INA Service Info

Coolant pump housing has been modified

Engines: 1.8 TDCI

Part no.: 538 0256 10

Fig. 1: Contents of the coolant pump package

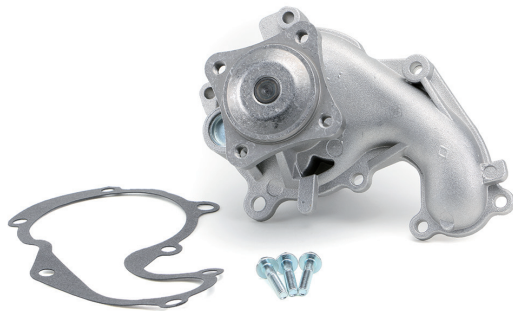
Use supplied screws

Fig. 2: Modified mounting points of the coolant pump

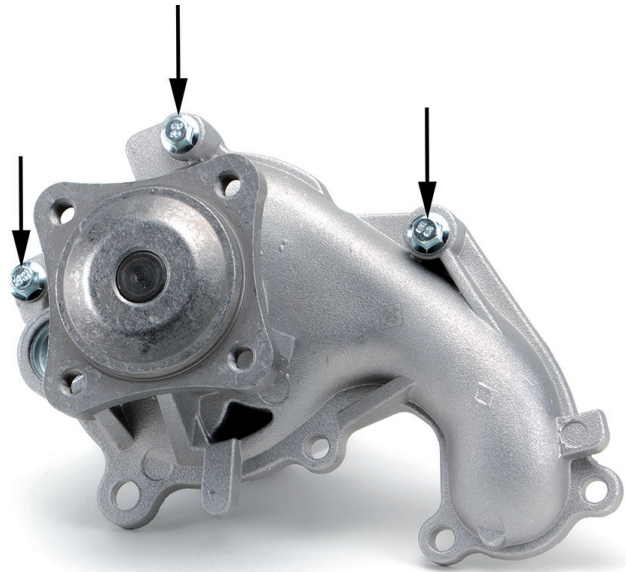
The housing of coolant pump 538 0256 10 has been modified. As a result, the screws (M6x37) supplied with the pump absolutely must be used at the three mounting points indicated (Fig. 2).

The increased material thickness at the three mounting points necessitates the use of these longer screws.
